REGIONAL REVIEW FINDING

ARC REVIEW CODE: R1805173

Name of Proposal: 1060 Hollowell (DRI 2815)

1060 DONALD LEE HOLLOWELL PARKWAY DRI #2815

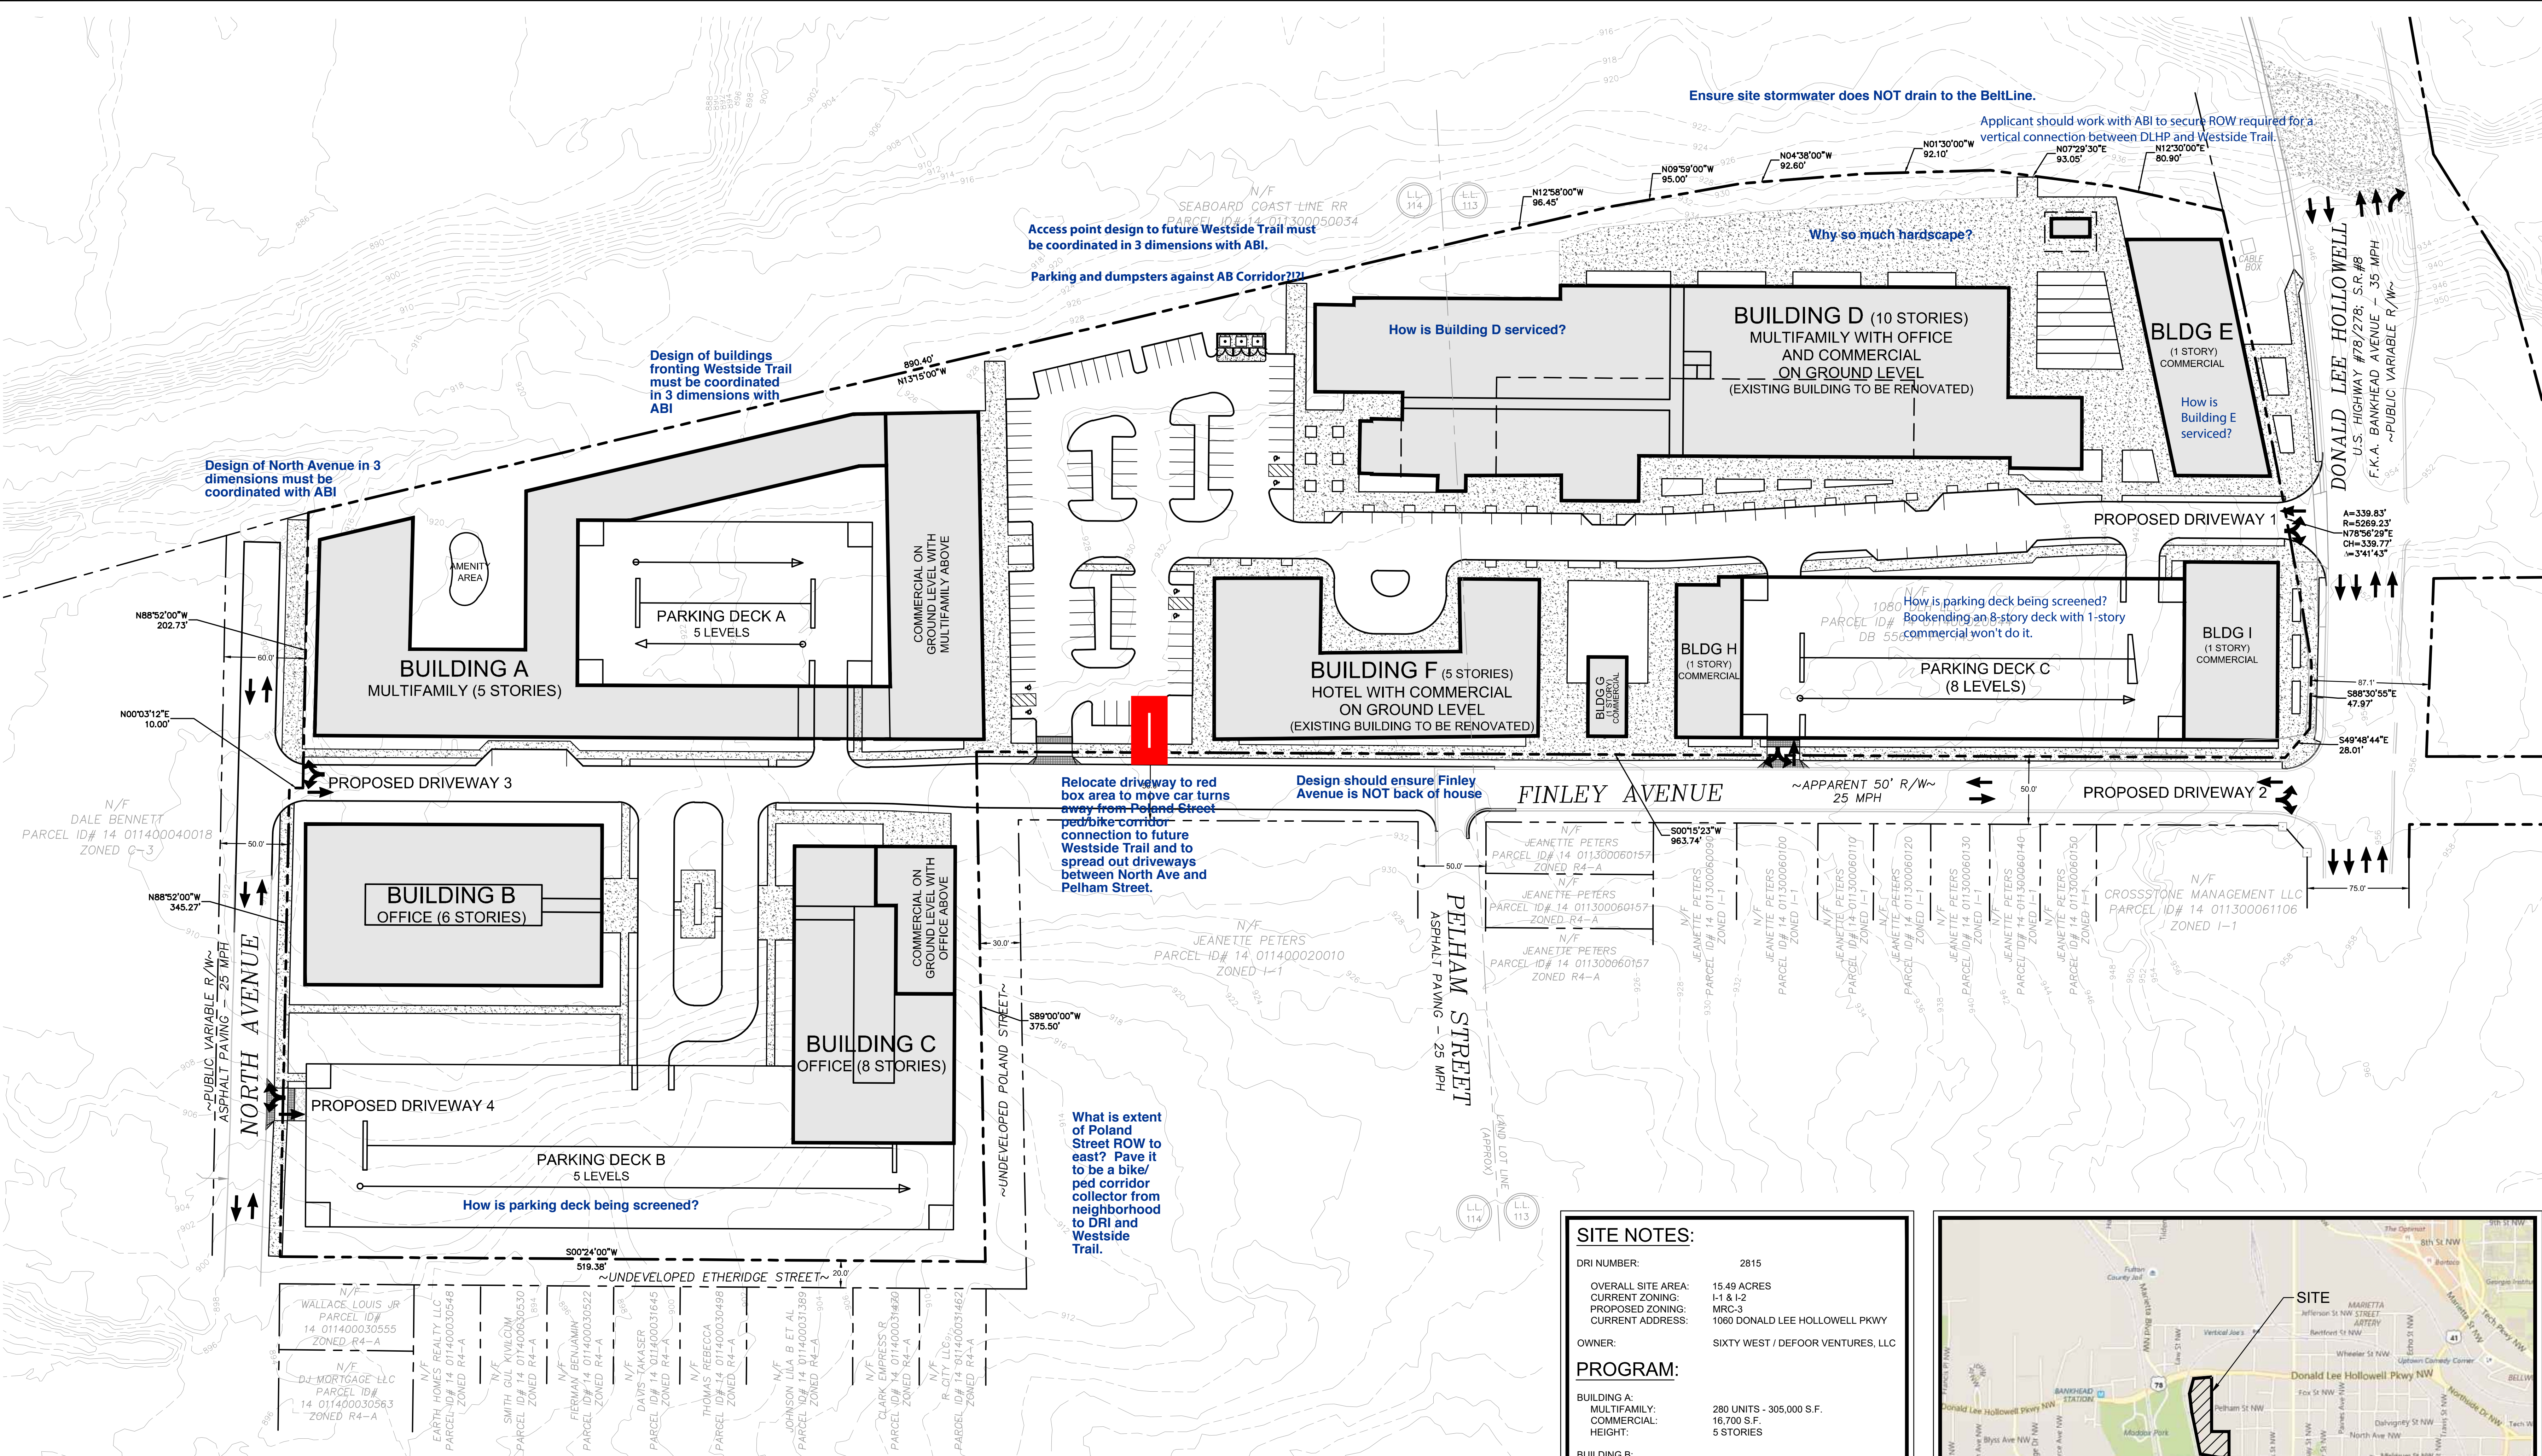
Design of North Avenue in 3 dimensions must be coordinated with ABI

Design of buildings fronting Westside Trail must be coordinated in 3 dimensions with ABI

Access point design to future Westside Trail must be coordinated in 3 dimensions with ABI.

Parking and dumpsters against AB Corridor?!?!

Ensure site stormwater does NOT drain to the BeltLine. Why so much hardscape?

Applicant should work with ABI to secure ROW required for a vertical connection between DLHP and Westside Trail.

How is Building E serviced?

How is Building D serviced?

How is parking deck C being screened? Bookending an 8-story deck with 1-story commercial won't do it.

Design should ensure Finley Avenue is NOT back of house

Relocate driveway to red box area to move car turns away from Poland Street ped/bike corridor connection to future Westside Trail and to spread out driveways between North Ave and Pelham Street.

What is extent of Poland Street ROW to east? Pave it to be a bike/ped corridor collector from neighborhood to DRI and Westside Trail.

How is parking deck B being screened?
